From: Paul Cuta [REDACTED]
Sent: Friday, April 21, 2017 9:03 AM
To: Firchow, Kevin
Cc: Bass, Kelly; Eskrich, Sara; Craig Stanley; Gregg Shimanski; Nathan Wautier
Subject: Re: 1603, 1605, 1609 & 1611 Monroe Street Comments
Attachments: 1603_A100c_PC AB Alt 2_17_0419.pdf; ATT00001.htm

Sixteen O Three Monroe

Level P1 Floor Plan
Auto Bank Alternative #2

A100c

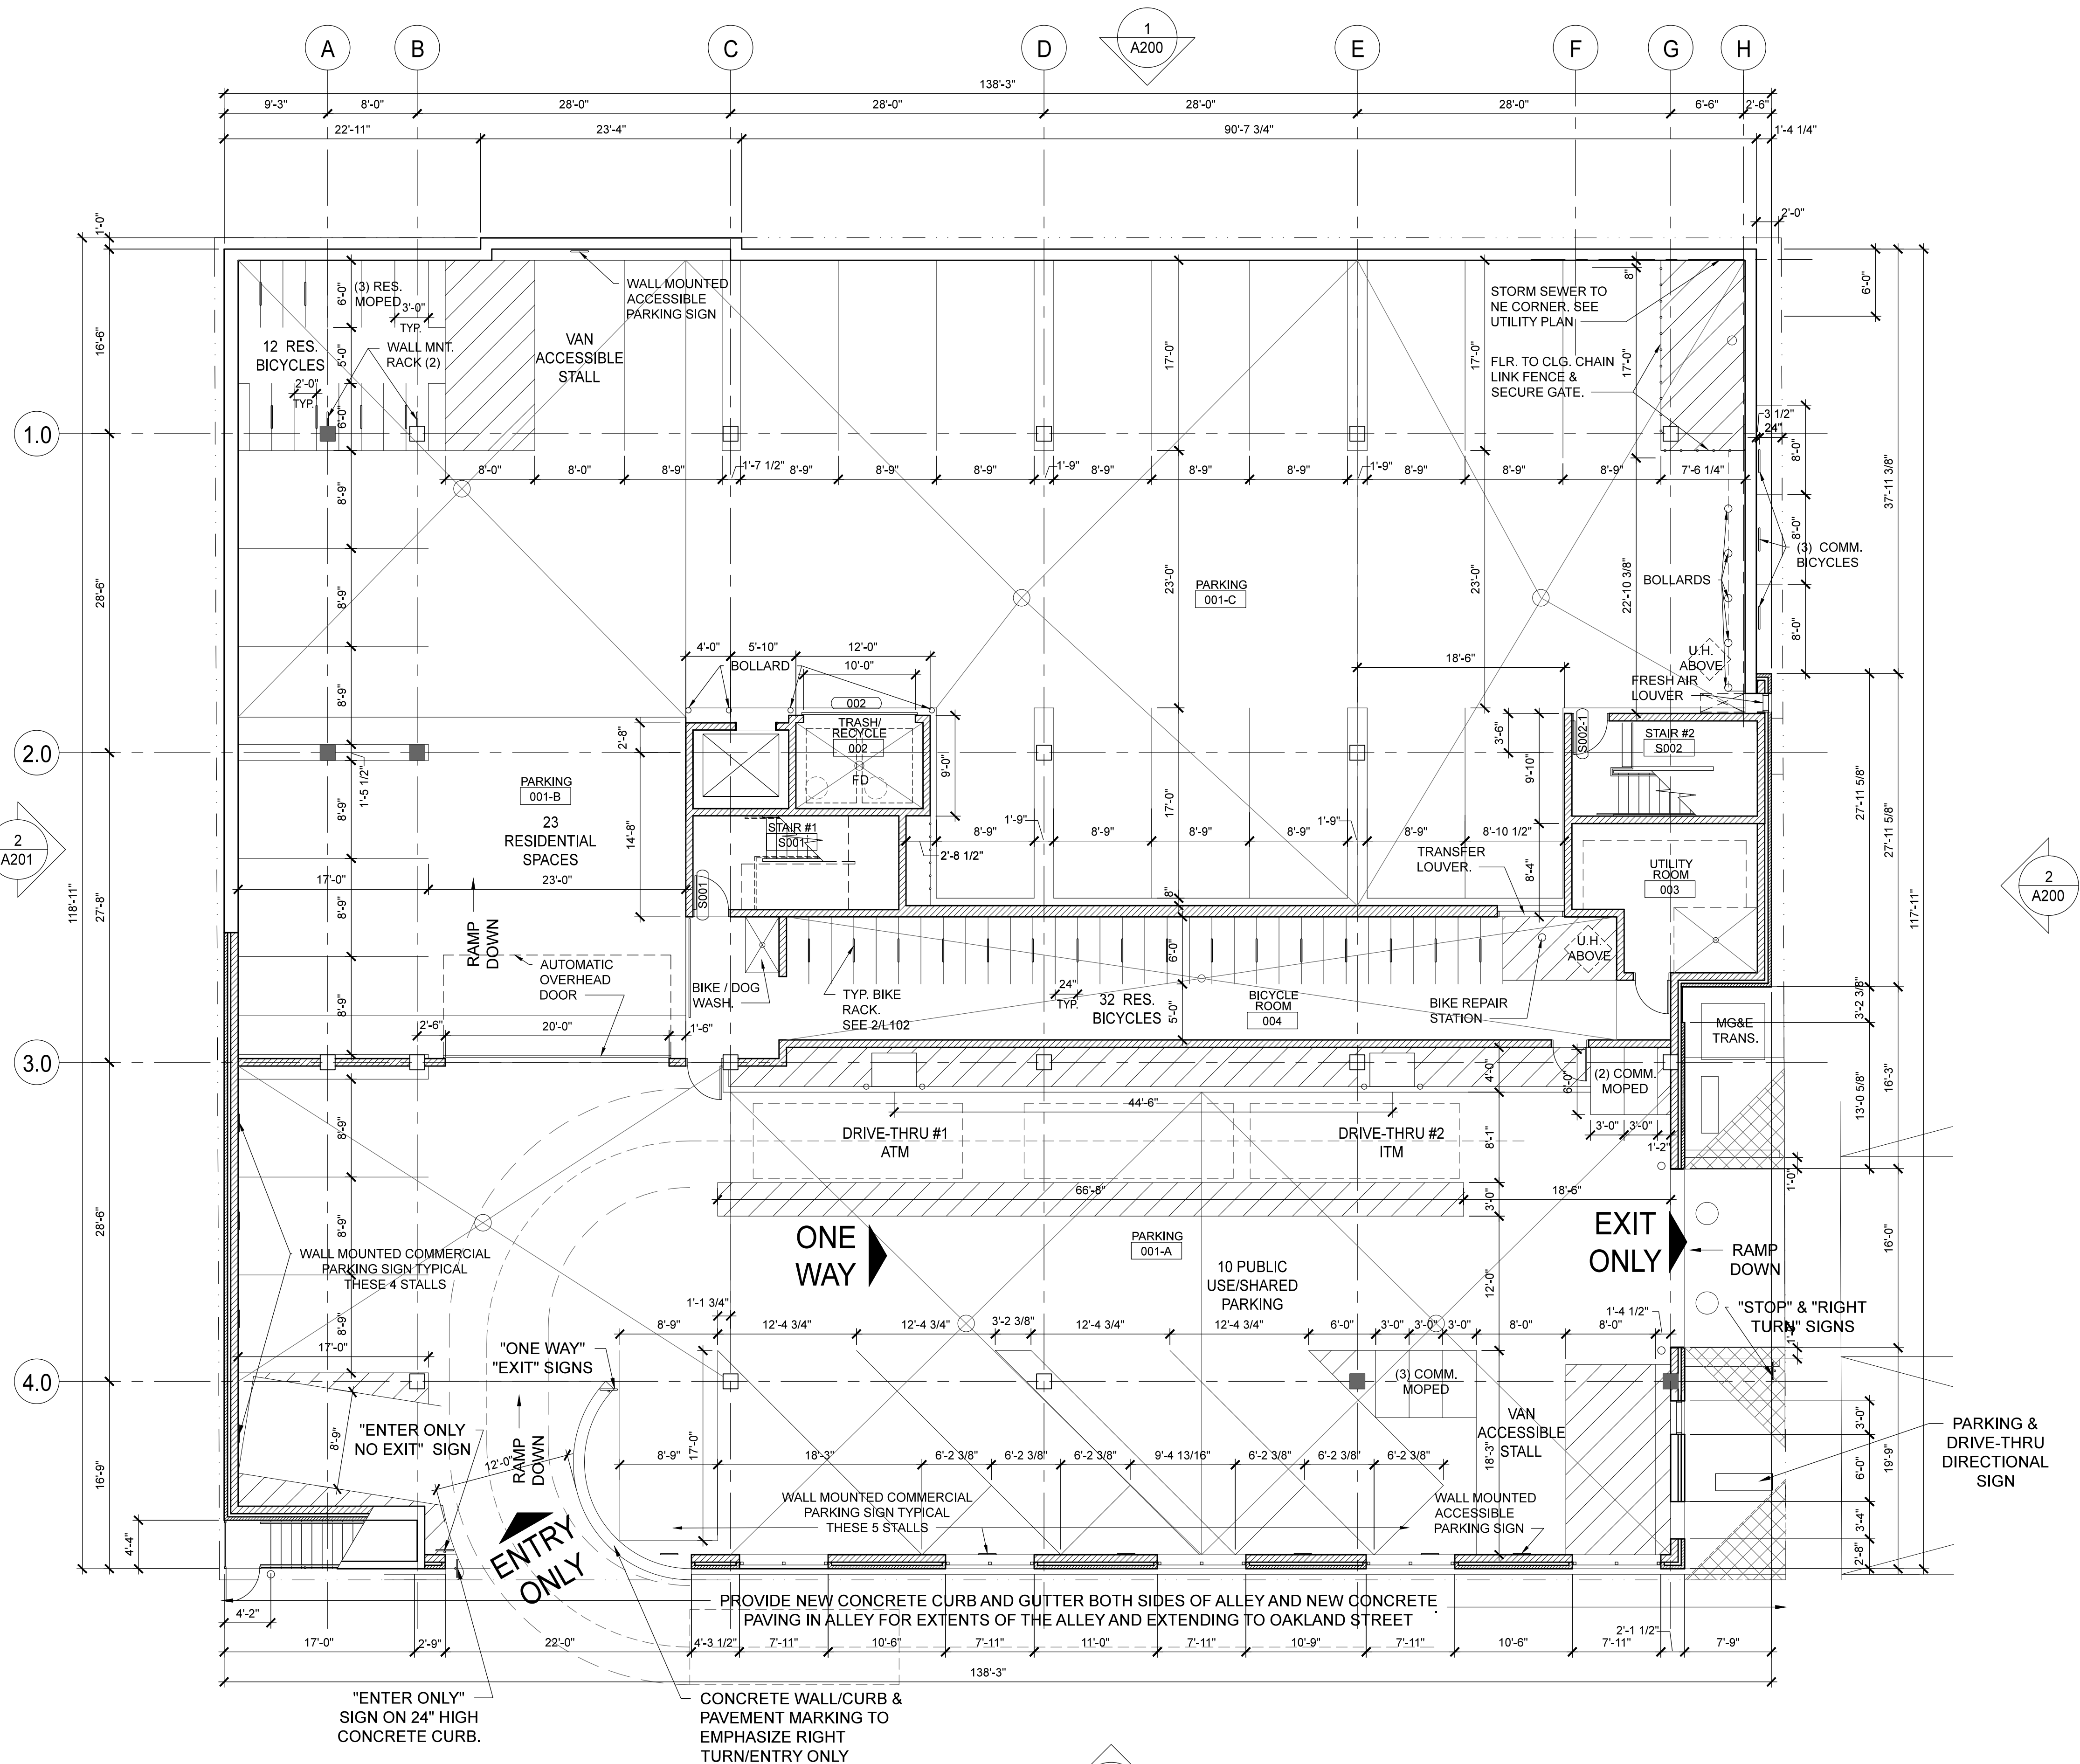
The P1 plan with option 2 (reverse flow) is attached. While the reverse flow option can work, there are several items we would like to note related to this option vs. option 1 as submitted:

1. Entry and access for the Bank customer and public parking is less intuitive as one will need to turn West up the alley to find the parking and drive-thru entry as opposed to seeing and entering directly off of Oakland. The Bank has noted that the majority of drive-thru traffic tends to be older clientele and feels the option 2 "way finding" is less than ideal and will require additional signage at the very least and may result in "drive-by" scenarios where one misses the entry and either continues on up the alley or stops and tries to back up to the entry. We believe this is less intuitive for the general public parking patron as well.

2. We believe appropriate signage for the alley access in option 2 is difficult and less likely to be visible and clear. We also believe appropriate caution signage can be added and more clearly visible to both vehicles and pedestrians on the alley related to the building egress traffic onto the alley in option 1 (warning alley traffic approaching from the west).

3. Vehicles entering the alley will likely continue west up the alley if they should decide not to bank or park, adding traffic to the alley beyond the building. We have heard clearly from the neighborhood meetings that traffic moving west, past the new building, is not desired and they would prefer provisions to limit or eliminate the likelihood of this increase in traffic.

4. The reverse flow option makes several of the public parking stalls more difficult to navigate, especially if there were ever to be a lengthy queue for the drive-thru. This scenario would also limit or impeded the ingress and egress from the residential parking. If a lengthy queue is a concern in option 1, we could increase the width of the entry point along Oakland from 16' to 20' to allow residential and public parking traffic to bypass the queue and in the worst possible scenario, the queue would be on Oakland which is wider and allows alternative flow as opposed to backing up in the alley. Note that we made the access to parking at Oakland narrower at the request of TE to try to reduce the temptation or likelihood of two-way traffic flow at that point. That said, based on information on historic usage and trends from the Bank, queuing is anticipated to be very, very minimal (current monthly usage at the Monroe Street location averages approximately one vehicle per hour and an increase in on-line banking).

5. The reverse flow option will cause vehicles in the drive-thru lane to look over their right to identify bypassing traffic where option one allows looking over the left side and mirror. Our experience suggests looking to the left generally is easier, more natural & safer.

6. Option 2 results in the elimination of 7 residential moped stalls which accounted for the equivalent of 2.3 residential auto stalls. While moped parking is not required, it has been used in the calculation of overall and reduced parking as presented and required of both planning and zoning (3 mopeds equivalent to 1 auto). The residential and public bike parking remains at the same quantities in both options.
